NOTICE TO PROCEED

Project: Grand Junction Fire Department Fire Station #3 Construction
IFB-4889-21-DH

Project:
Grand Junction Fire Department
Fire Station #3
GMP Estimate

A3-6

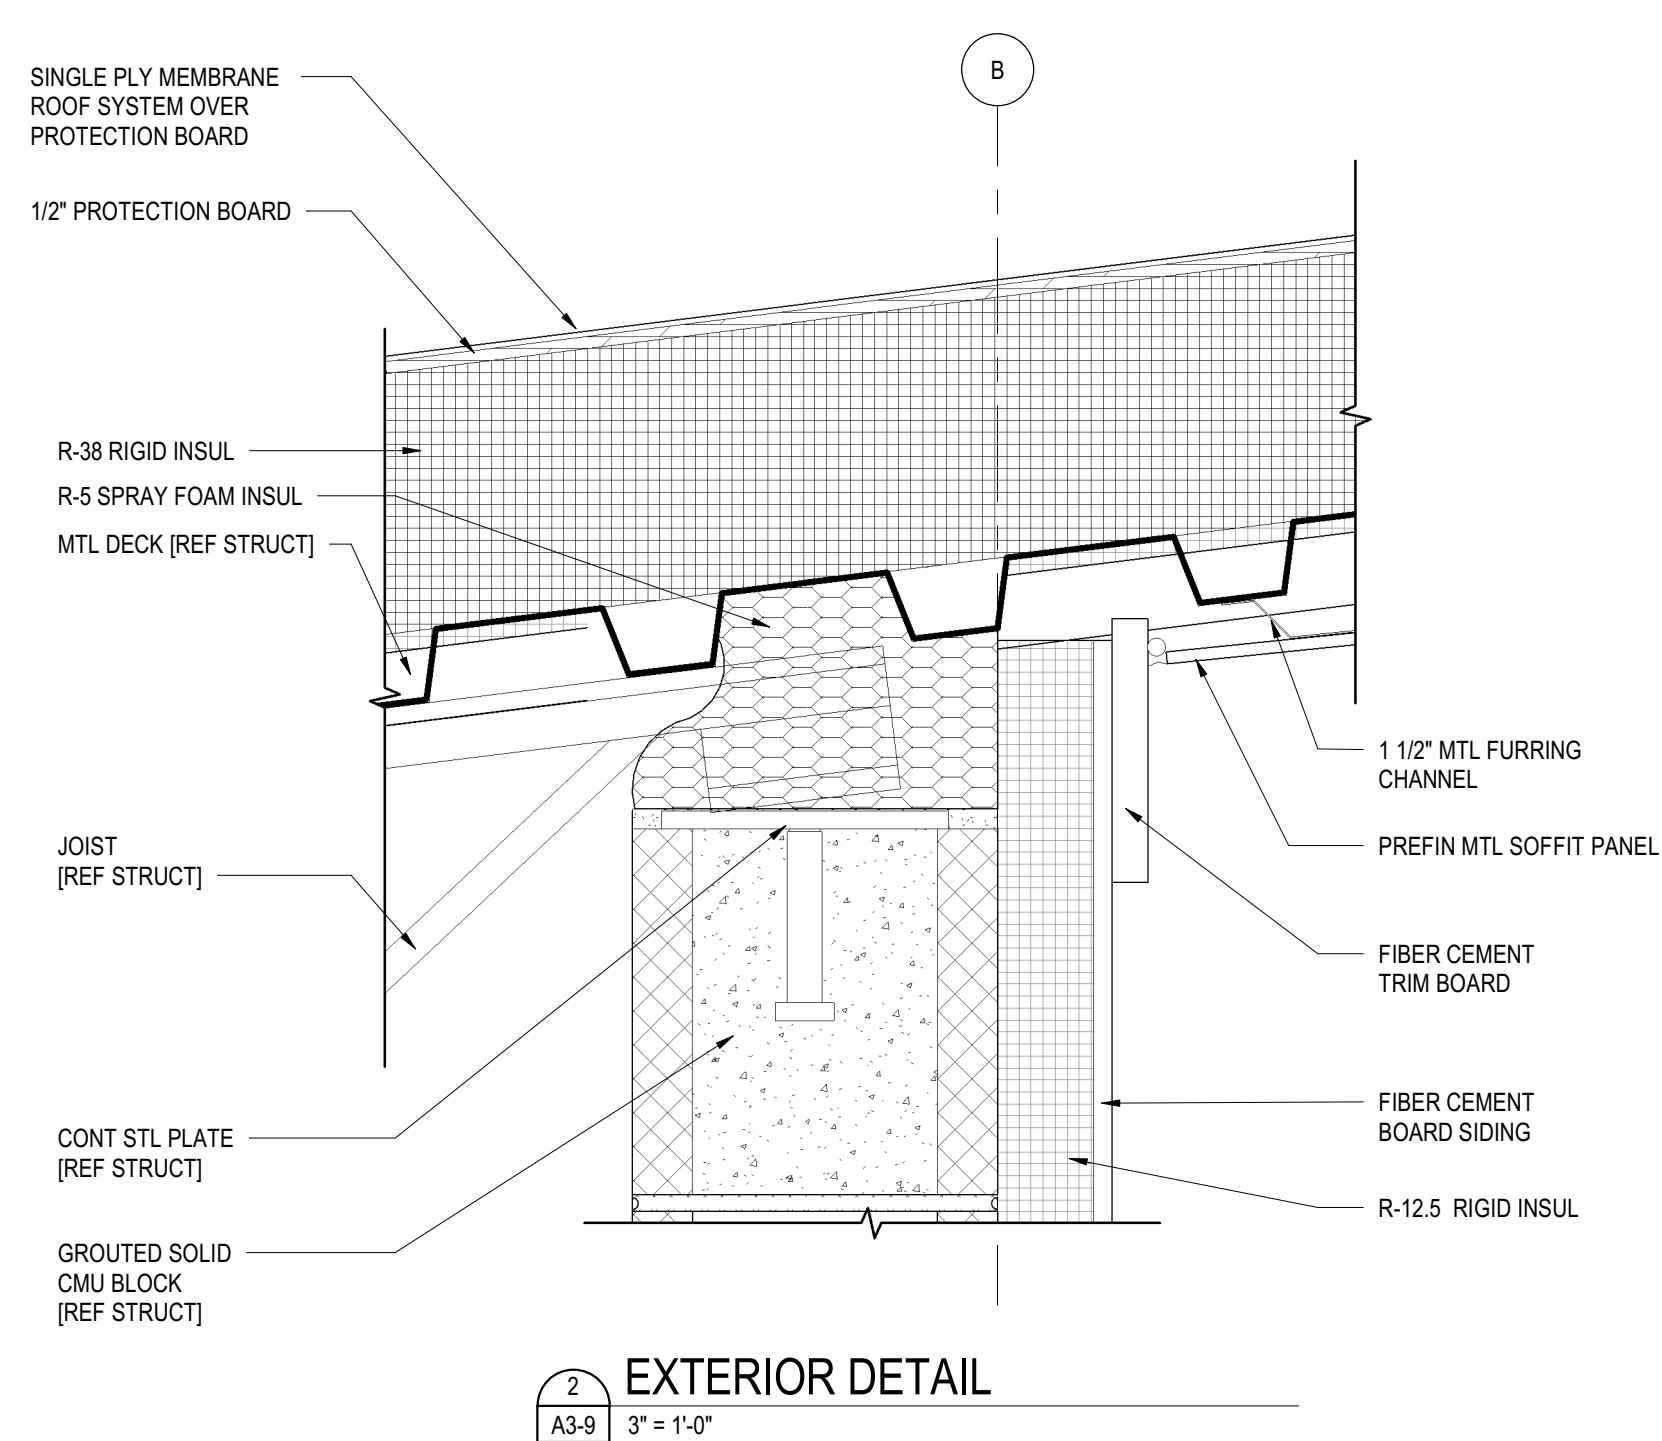
5. Please see attached revised Architectural Sheets A3-6 and A3-9:
 - Revised Detail 1/A3-6 on sheet A3-6, to include dimension string from roof surface to bottom of fiber cement siding.

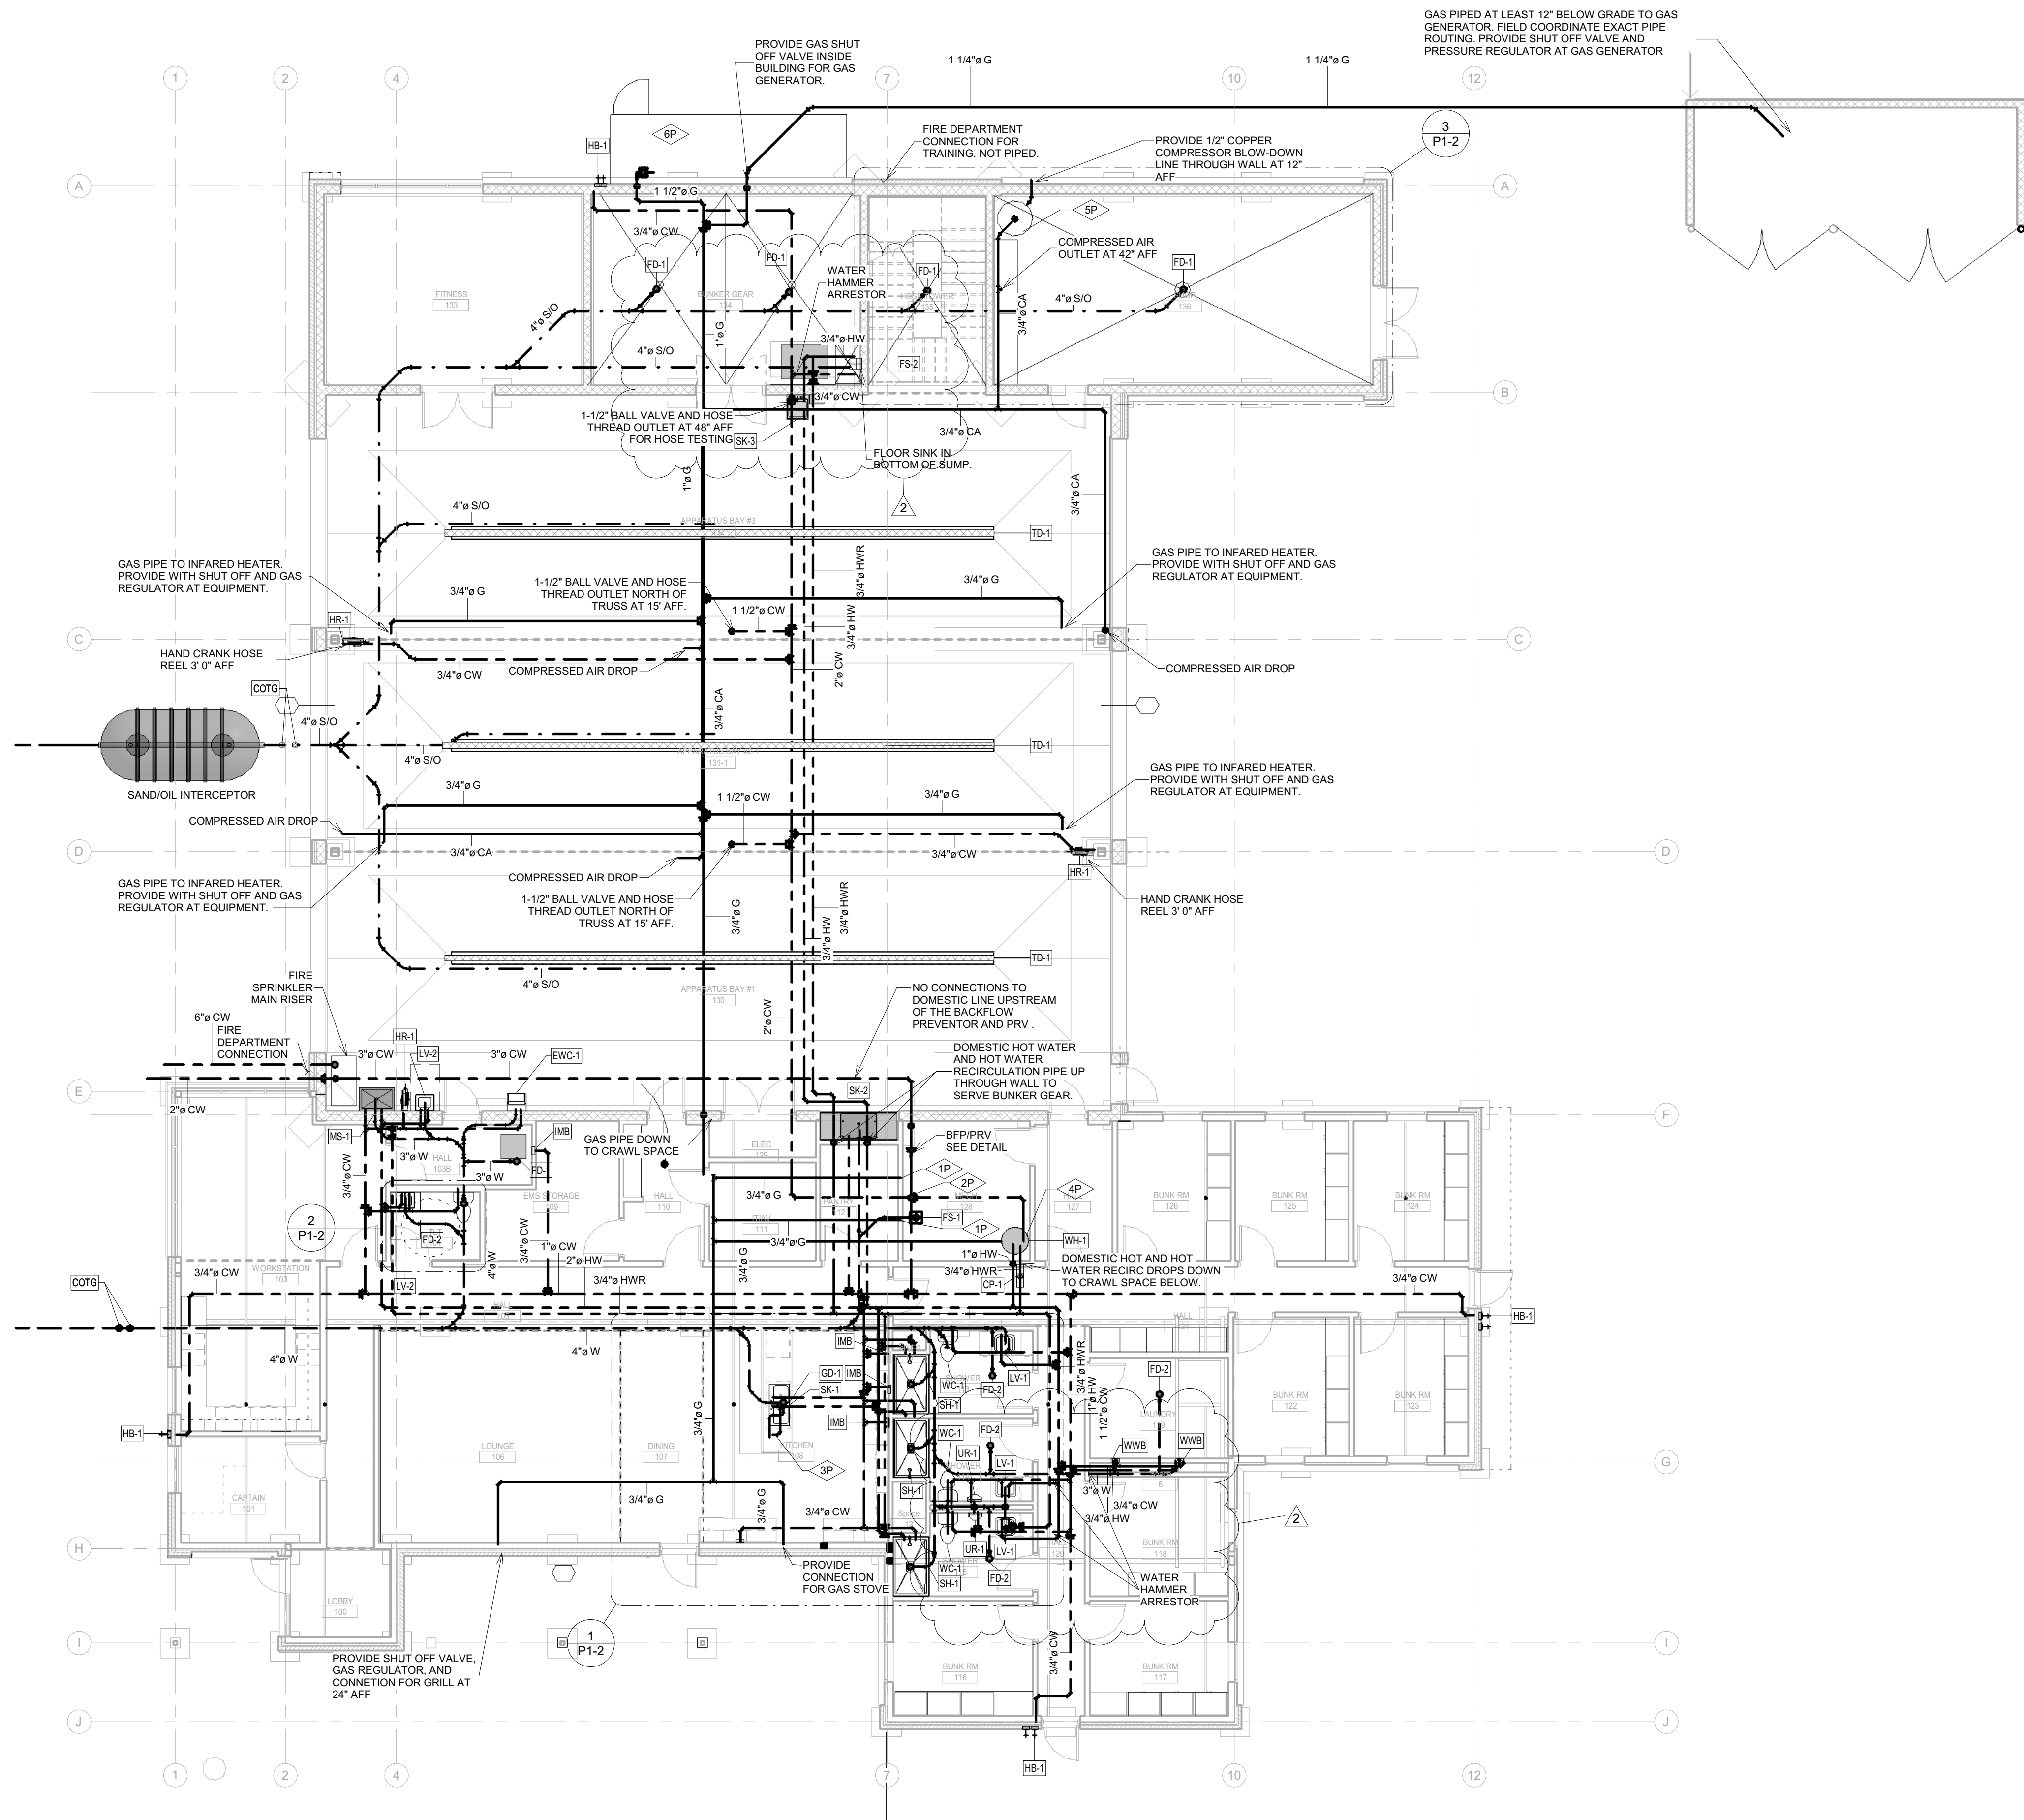
- A. The drainpipe has been called out on sheet P1-1 as 4" dia. See attached revised drawing. The 3" floor sink will work at this location to drain the extractor washer.

- Added Detail 10/A3-9 and Detail 11/A3-9 to sheet A3-9 for roof flashing detail to brick wall above roof.
6. Please see attached revised Plumbing and Electrical Sheets P1-1, P3-2 and E1-3. These clouded changes are in response to comments from the Building Department.
